The Commission has issued the enclosed Amendments Nos. 5 and 3 to Facility Operating Licenses Nos. DPR-44 and DPR-56 respectively, for the Peach Bottom Atomic Power Station, Units No. 2 and 3. These amendments include Changes Nos. 6 and 3 respectively and are in response to your request of July 12, 1974.

PEACH BOTTOM ATOMIC POWER STATION, UNIT 2

AMENDMENT TO FACILITY OPERATING LICENSE

SUPPORTING AMENDMENTS NOS. 5 AND 3 TO LICENSES NOS. DPR-44 AND DPR-56

Figure 3.5.1.A

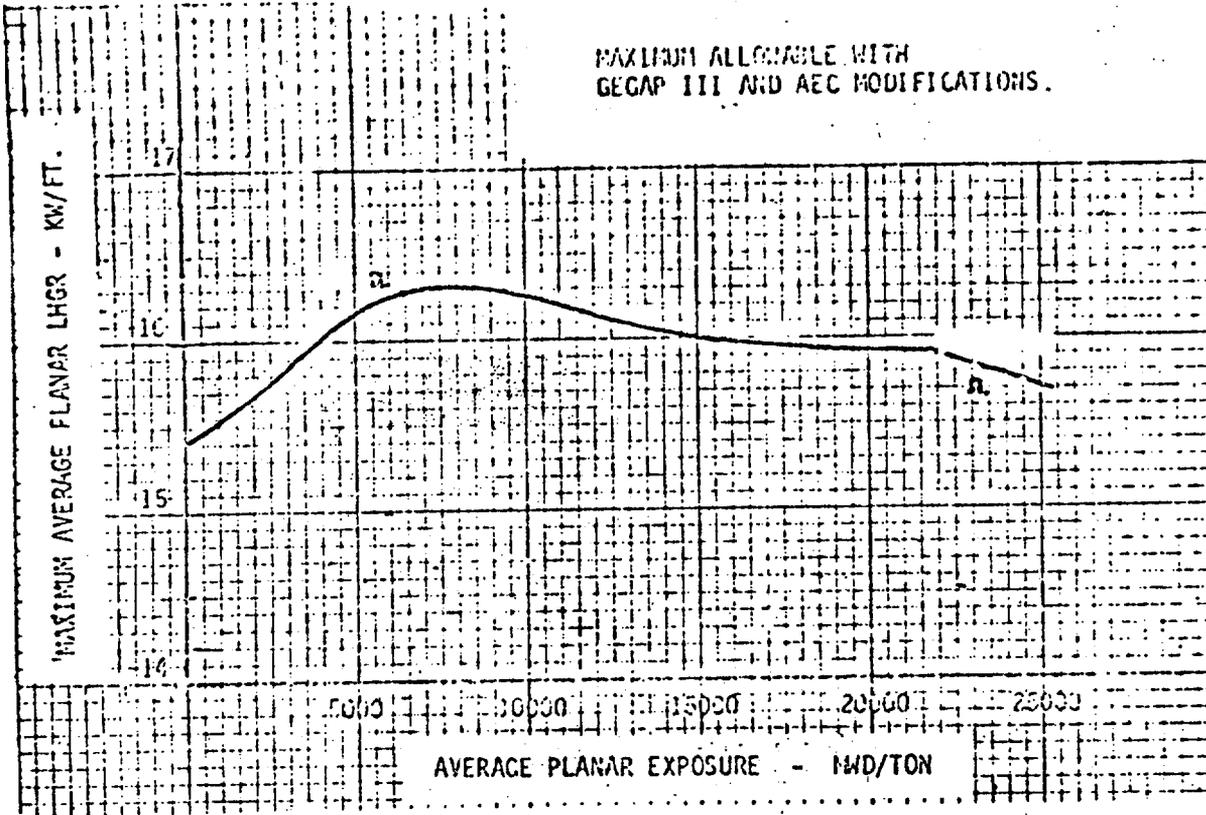
During steady state power operation, the average linear heat generation rate (LHGR) of all the rods in any fuel assembly, as a function of average planar exposure, at any axial location, shall not exceed the maximum average planar LHGR shown in Figure 3.5.1.A or Figure 3.5.1.B.*

The maximum average planar linear heat generation rates shown in Figures 3.5.1.A and 3.5.1.B are based on calculations employing the GEGAP III model described in the General Electric reports NEDO-20181, "GEGAP III, A Model for the Prediction of Pellet-Clad Thermal Conductance in BWR Fuel Rods," November 1973 with related proprietary information provided in NEDC-20181 (Proprietary), November 1973.

Philadelphia Electric Company has recalculated the fuel temperature response to the design basis loss-of-coolant accident for Peach Bottom Atomic Power Station, Units 2 and 3 using GEGAP III and has determined new MAPLHGR curves for the three fuel types presently in use. These curves (Figures 3.5.1.A and 3.5.1.B of the revised Technical Specifications) maintain the Interim Acceptance Criteria (IAC) of 2300°F peak clad temperature during a LOCA while allowing steady state power operation at higher average planar linear heat generation rates.

The proposed MAPLHGR values, even though of higher value than currently specified in the Technical Specifications, maintain a calculated peak clad temperature within the limitation imposed by the IAC. Since the peak clad temperature is not increased during a LOCA the probability or consequences of the postulated design basis LOCA is not increased and the margin of safety is not diminished.

PBAPS INITIAL CORE TYPE 2

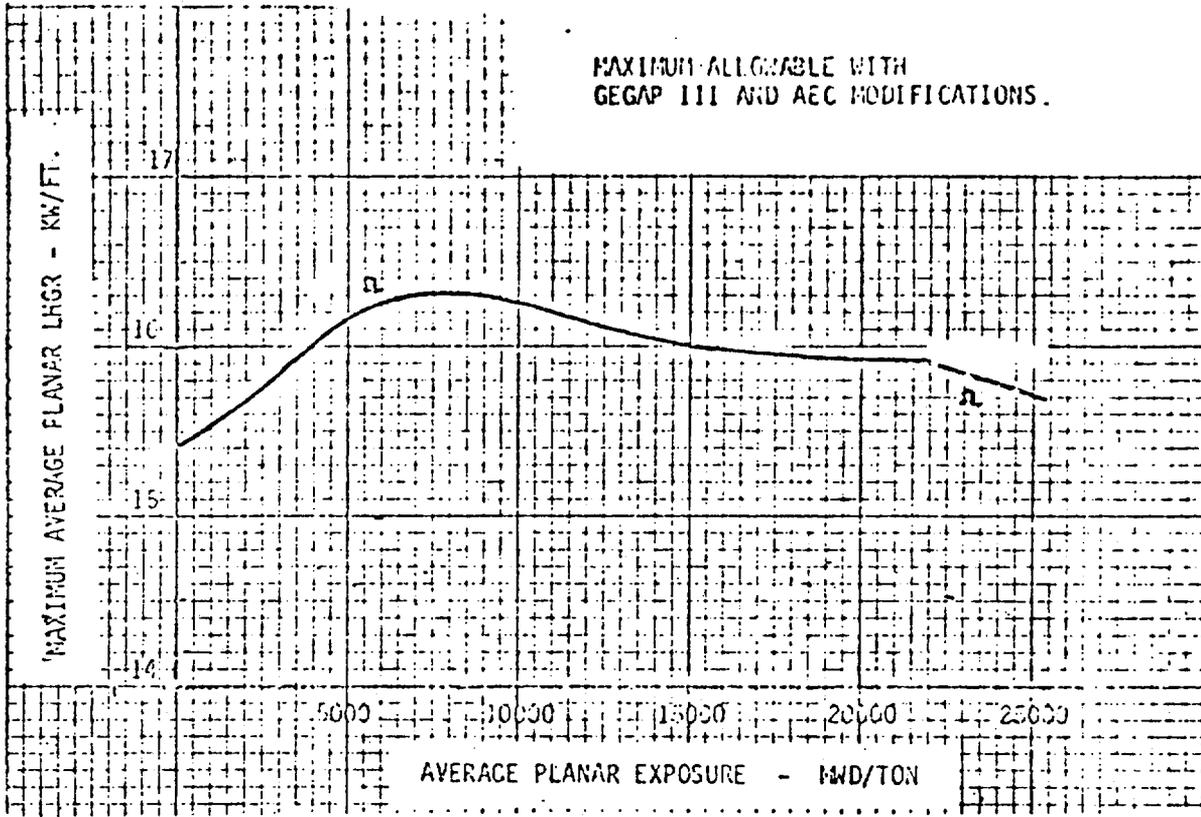
During steady state power operation, the average linear heat generation rate (LHGR) of all the rods in any fuel assembly, as a function of average planar exposure, at any axial location, shall not exceed the maximum average planar LHGR shown in Figure 3.5.1.A or Figure 3.5.1.B.*

The maximum average planar linear heat generation rates shown in Figures 3.5.1.A and 3.5.1.B are based on calculations employing the GEGAP III model described in the General Electric reports NEDO-20181, "GEGAP III, A Model for the Prediction of Pellet-Clad Thermal Conductance in BWR Fuel Rods," November 1973 with related proprietary information provided in NEDC-20181 (Proprietary), November 1973.
